27th July, 2010.

THESE ARE THE SCHEMATICS FOR COMBO STAR Vers "BB"

COMBO STAR

| 5 of 16 | TITLE:- | E:\COMBO-SCHEMATIC-PROJECT-121109\COMBO-DSP_MBD.sch FOR PANEL |

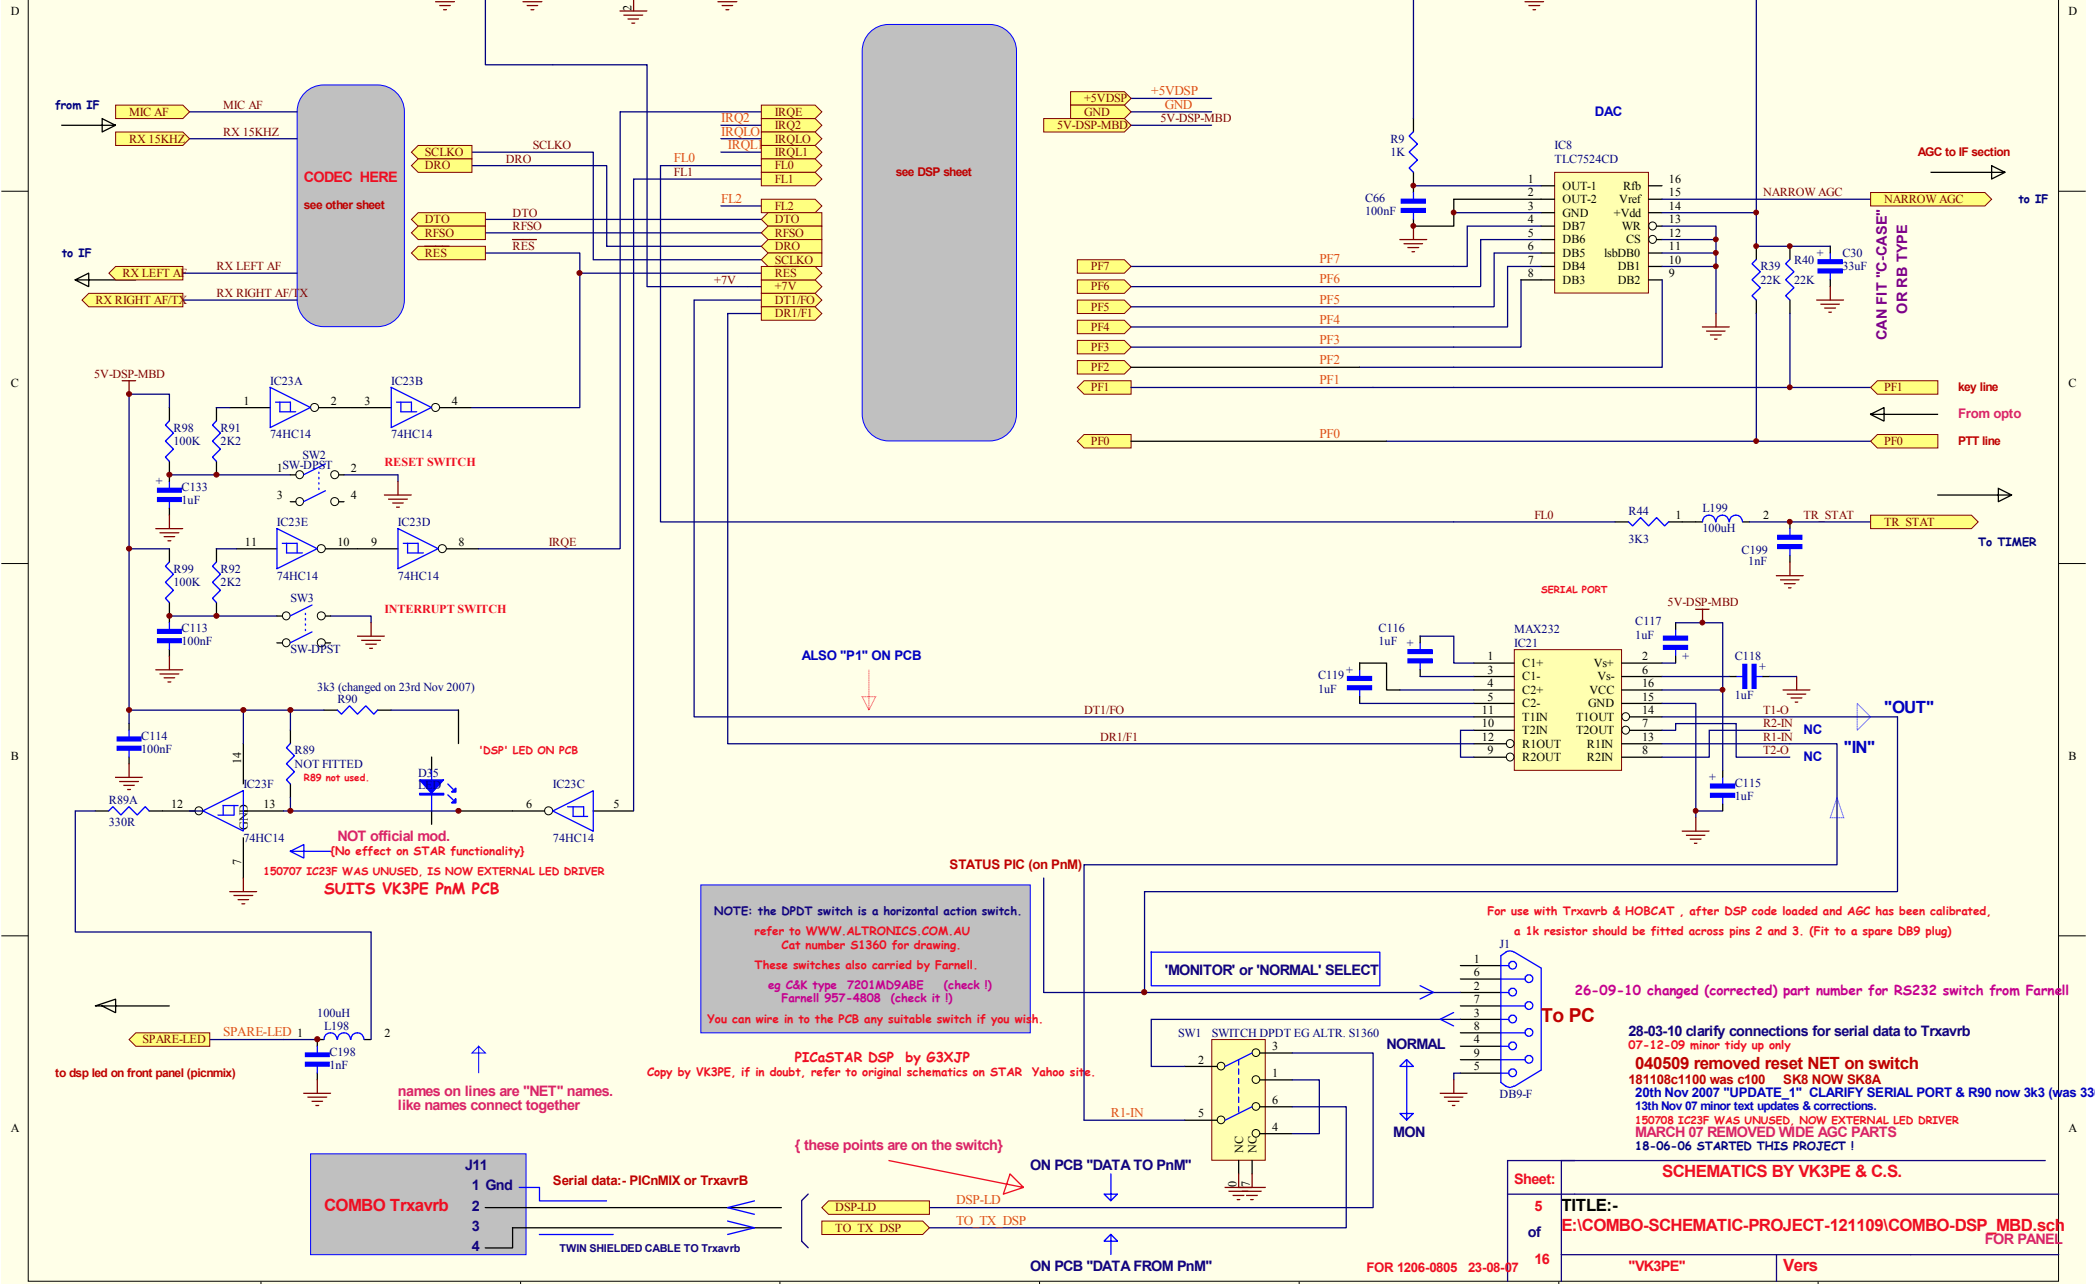
DSP motherboard, (sheet 5) The RS232 switch Farnell part number has been corrected. Please verify all numbers given in these documents though by checking Data sheets etc.

The DSP motherboard area (sheet 5) has been updated to clarify the connections from the Serial Data switch routing to the Trxavrb PCB (or PICnMIX if used) See bottom area of the sheet.

26-09-10 changed (corrected) part number for RS232 switch from Farnell

28-03-10 clarify connections for serial data to TrxavrB
07-12-09 minor tidy up only
040509 removed reset NET on switch
181108c1100 was c100 SK8 NOW SK8A
20th Nov 2007 "UPDATE_1" CLARIFY SERIAL PORT & R90 now 3k3 (was 330R)
13th Nov 07 minor text updates & corrections.
150708 IC23F WAS UNUSED. NOW EXTERNAL LED DRIVER
MARCH 07 REMOVED WIDE AGC PARTS
18-06-06 STARTED THIS PROJECT!

| 13 of 16 | TITLE:- H:\COMBO-SCHEMATIC-PROJECT-121109\COMBO-DDS_FILTER.Sch | |

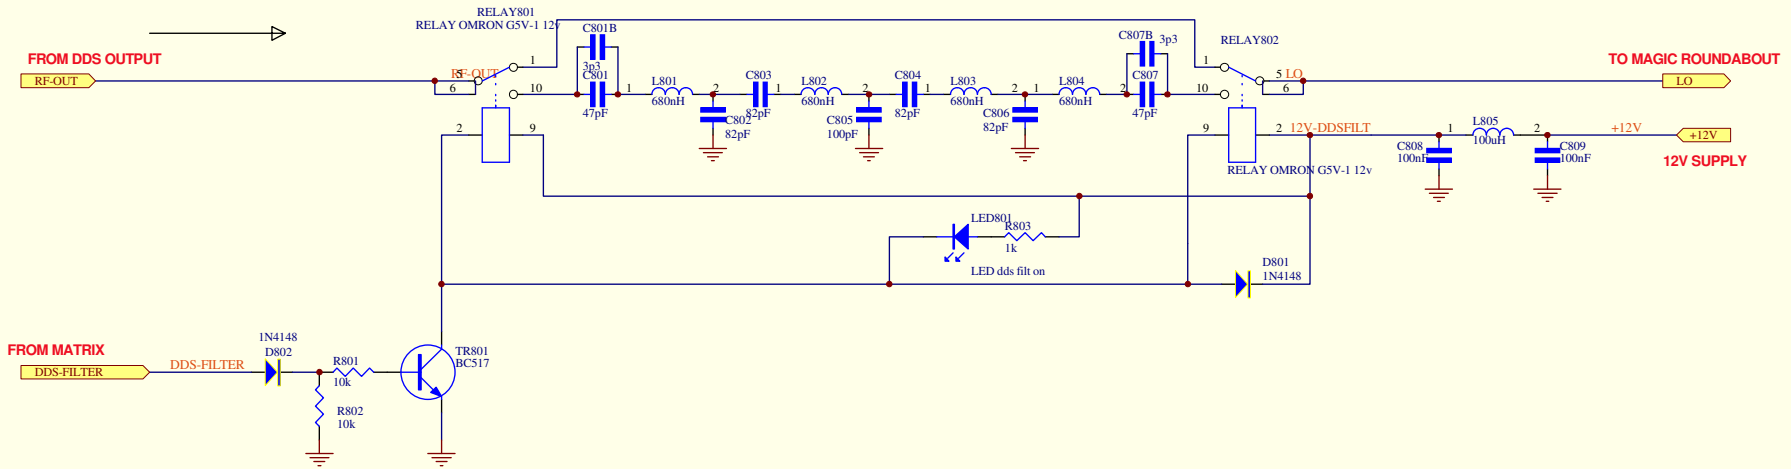
010509 add led on filter
 010509CHANGED F/P FOR BC517'S
 14-01-09
 15-12-08 UPDATED FOR COMBO USE
 #994 9585 OMRON 65V-1 RELAY FROM FARNELL
 also Altronics (Aus) S4113
 01-10-09
 SEPT 2007 VK3PE * C.S.

Sheet: **14-01-09** PICASTAR SCHEMATICS BY VK3PE
BASED ON ORIGINALS (C) BY G3XJP

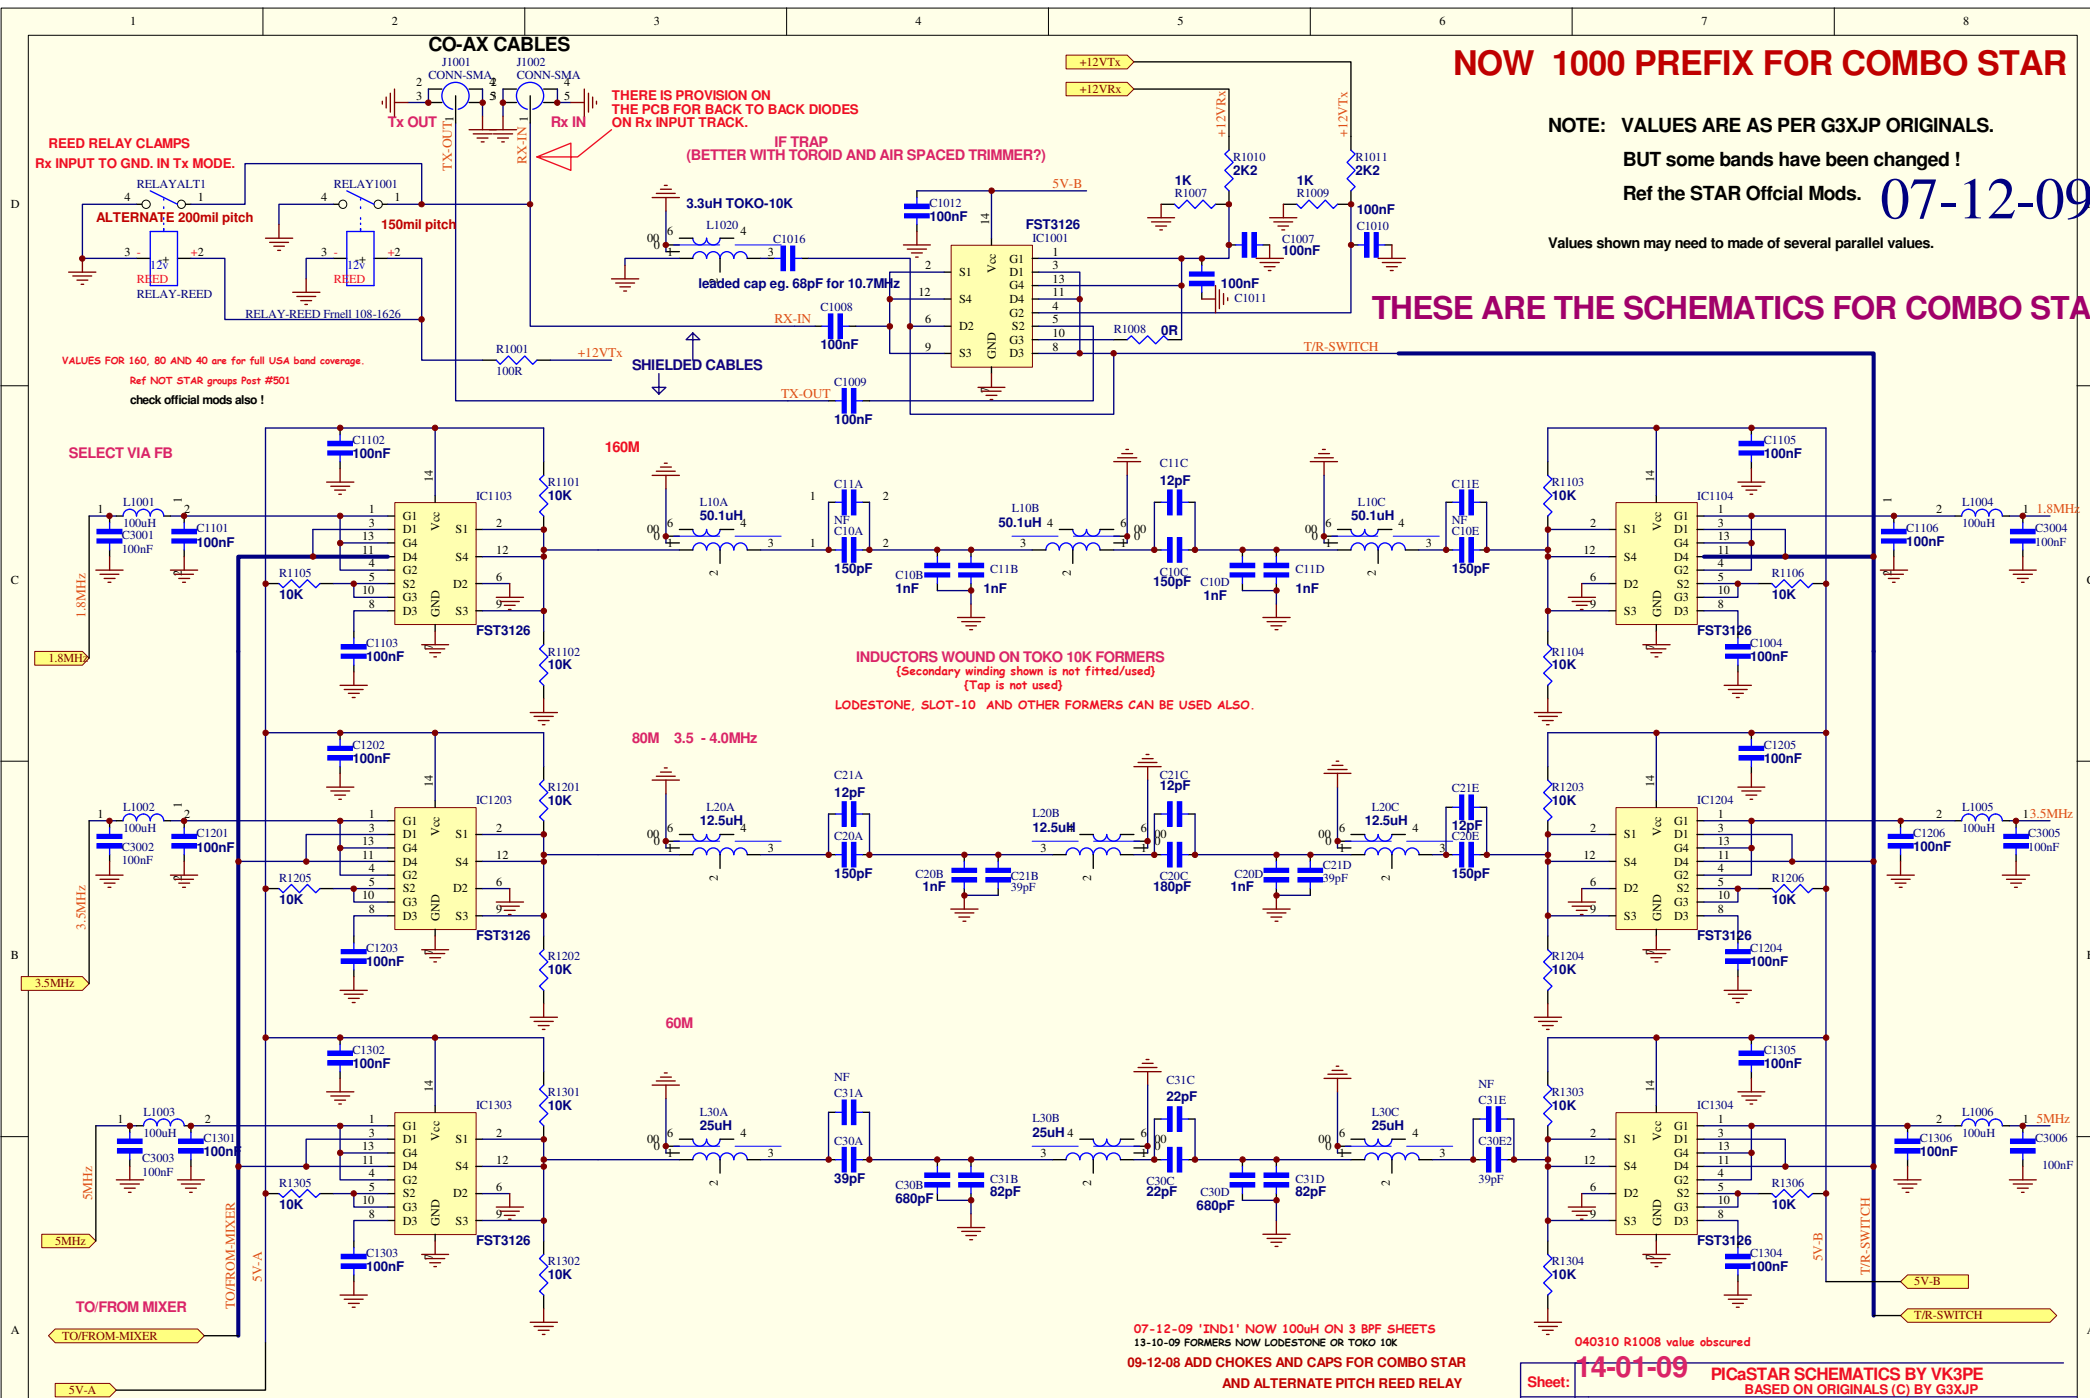
07-12-09 'IND1' NOW 100uH ON 3 BPF SHEETS

040310 R1008 value obscured

| 9 | TITLE:- | H:COMBO-SCHEMATIC-PROJECT-121109:COMBO-MATRIX.SCH |

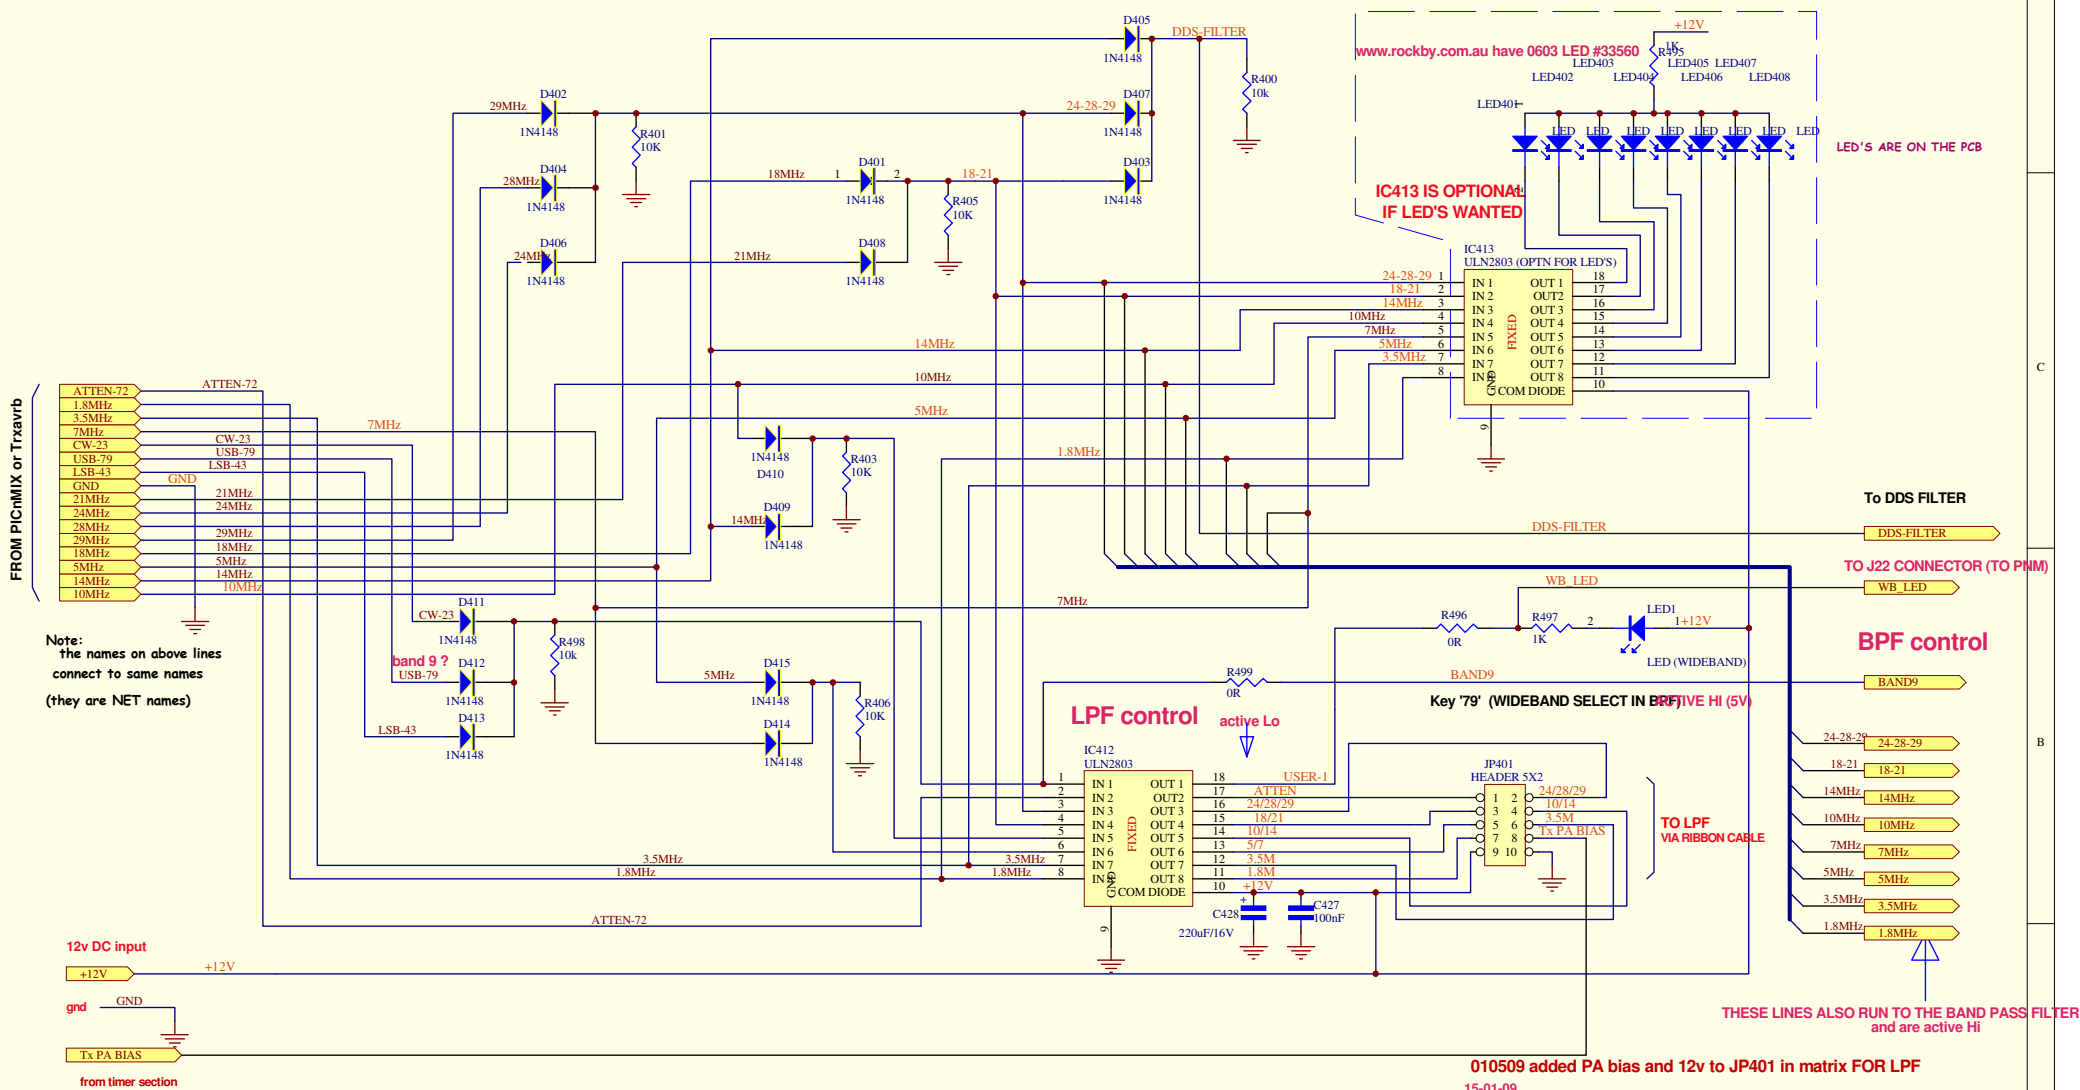
010509 added PA bias and 12v to JP401 in matrix FOR LPF
15-01-09
ULN2803'S CORRECTED
5th Dec 2007 Update_1:- error in LPF control designation
011207 cosmetic update only
